February 6, 2012

Re: AHRI Comments – Regional Labeling for Heating and Cooling Equipment (16 CFR Part 305) (Project No. P114202)

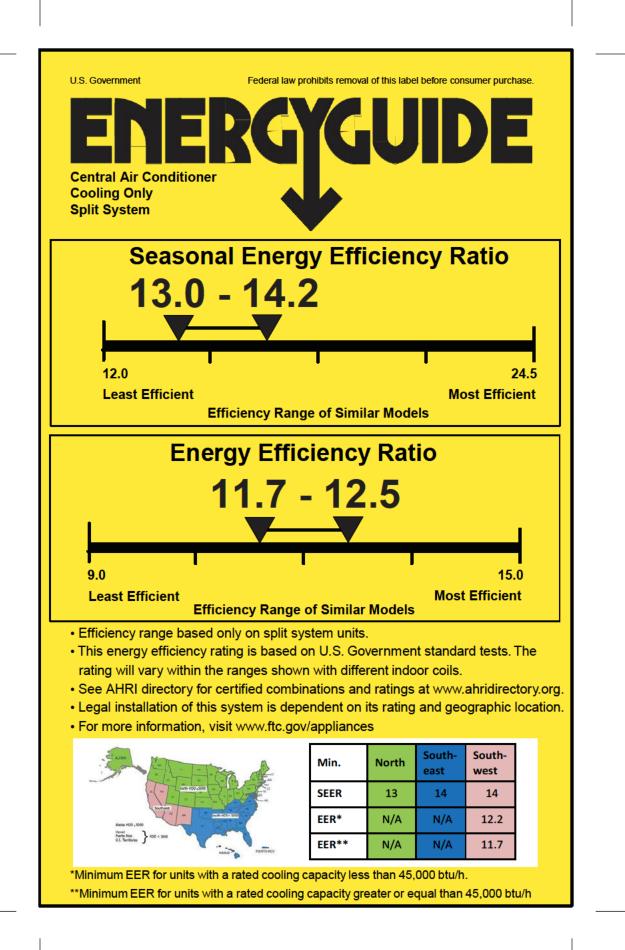
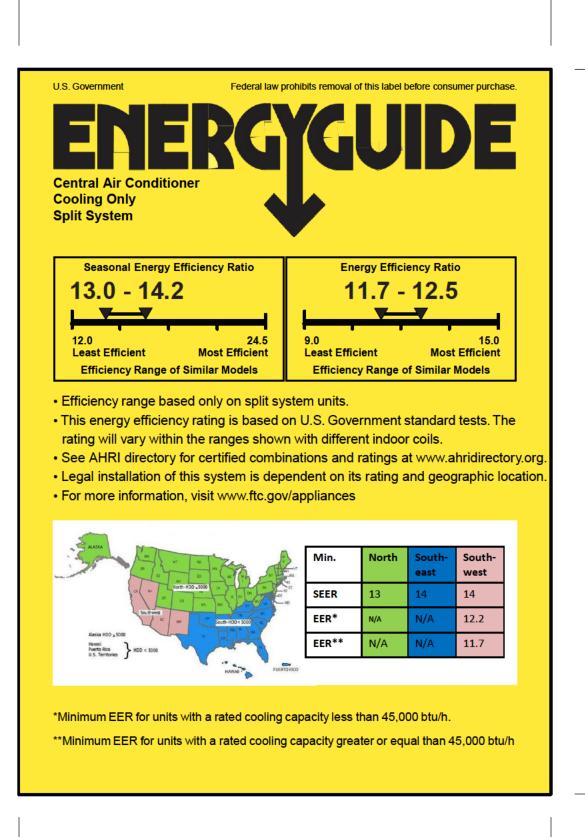
Attached for your review and consideration are two draft EnergyGuide labels for splitsystem central air conditioners. The labels can also be applied to single-package air conditioners since the regional standards specify a minimum EER for those products in the U.S. southwest region. The two labels are identical in terms of content but are formatted differently. We believe that the modified labels would enable manufacturers to adequately disclose the information associated with the new energy conservation standards. The draft labels will allow the FTC and DOE to coordinate their enforcement efforts and can be applied on manufacturers' condensing units. Each label includes an efficiency range for SEER and EER and it is clearly indicated that the rating will vary within the ranges shown with different indoor coils. A map that distinguishes the regions within the United States has been included and a table specifying the minimum SEER and EER levels in various regions has been incorporated alongside the map. We feel that the map and the table in each label adequately allow manufacturers to inform distributors, contractors and consumers about the appropriate regions. Each draft label also points consumers and other industry members towards the AHRI directory for information on AHRI certified matched combinations. The manufacturer does not have any control over where and how the equipment is installed once it leaves the manufacturing facility; the draft EnergyGuide labels account for this issue and place the onus upon the party that installs the equipment by specifying that legal installation of the system is dependent on its rating and geographic location. We believe that these proposed EnergyGuide labels will help achieve two important goals: (1) the labels will help FTC to meet its goals of providing consumers and industry members the necessary information about the equipment, and (2) the labels will help DOE with its enforcement of the regional standards.
